ADDENDUM NO.2

**Alamogordo Family Recreation Center HVAC Upgrade (Public Works Bid Number 2017-016)
1100 Oregon Ave.
Alamogordo, New Mexico**

**RBM Engineering, Inc.
1065 S. Main, Bldg, D, Ste. A
Las Cruces, New Mexico 88005**

MSD-1

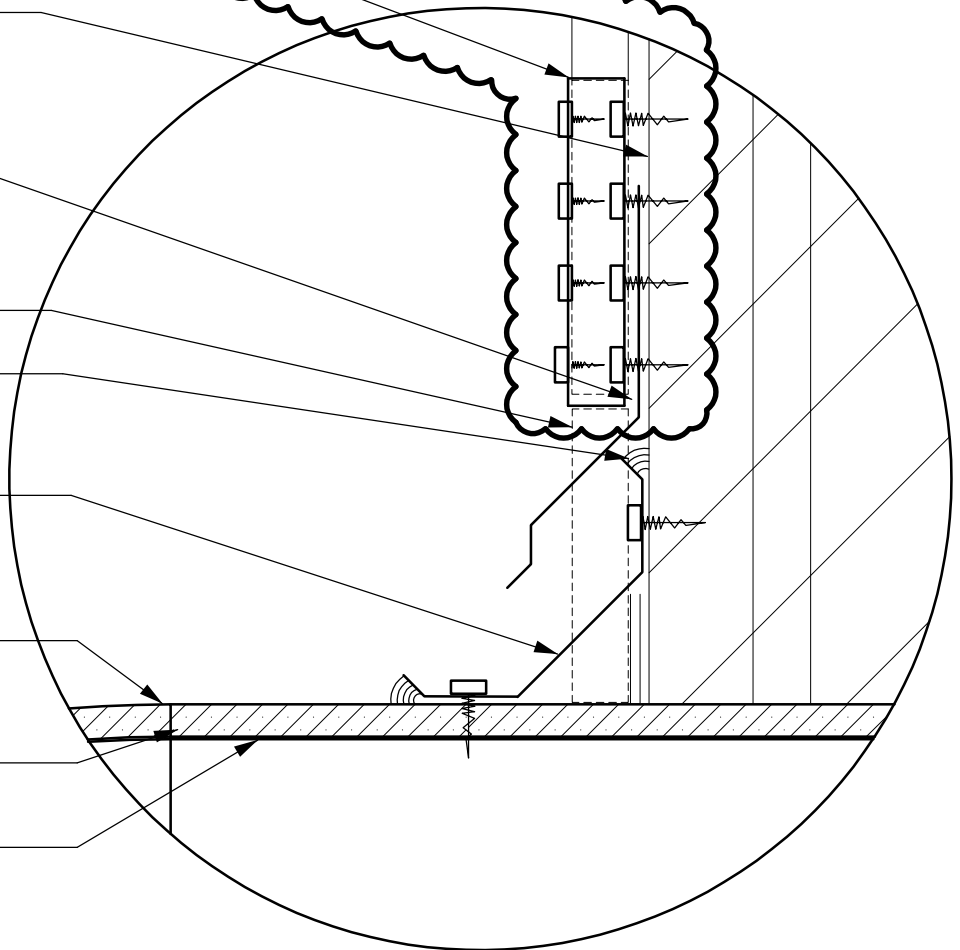
- 1) Question regarding the repair or replacement of the exterior wall panel (R Panel) at HVAC unit wall penetrations: Only the area of the wall panel around the penetration shall be replaced/repared for a water tight seal. The entire full vertical wall panel shall not be replaced to accommodate the new wall penetrations. Refer to attached supplemental drawing MSD-1 for clarification.

NEW METAL PANEL SIDING
PATCH INSTALL PER MFGR'S
RECOMMENDATIONS.

SLIDE COUNTER FLASHING
UNDER EXISTING METAL
SIDING AND SECURE TO
WALL

CUT EXISTING METAL SIDING
TO ACCOMMODATE NEW
FLASHING

18 GA GALVANIZED STL
BASE FLASHING SECURE TO
WALL AND DUCT

MSD-2

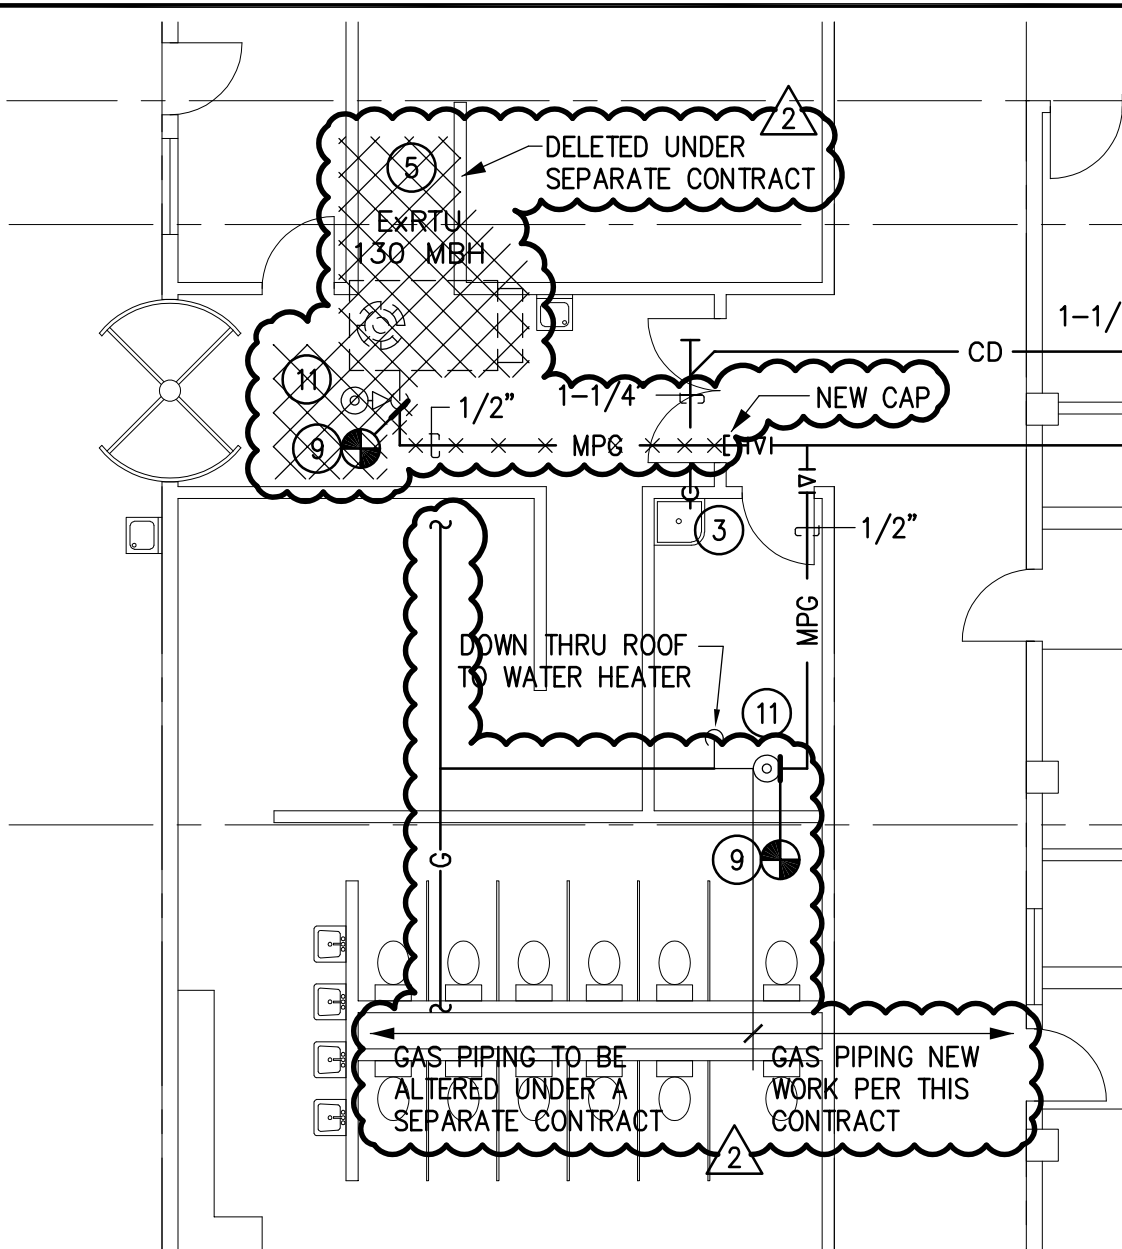
1. Sheet MP-0.1: Pipe Material Schedule: Condensate Drain Lines, Clarification – Type L Copper shall be used above the roof and does not require insulation. Piping inside building shall be either Type L copper or schedule 40 PVC and shall be insulated as specified.
2. Sheet MP-1.0: HVAC & Plumbing New Work Plan, Gas Line Clarification – Refer to attached drawing MSD-2 indicating interface with the new gas line serving the locker room renovation (separate contract) and its connection to the new gas distribution for the HVAC Upgrade project.
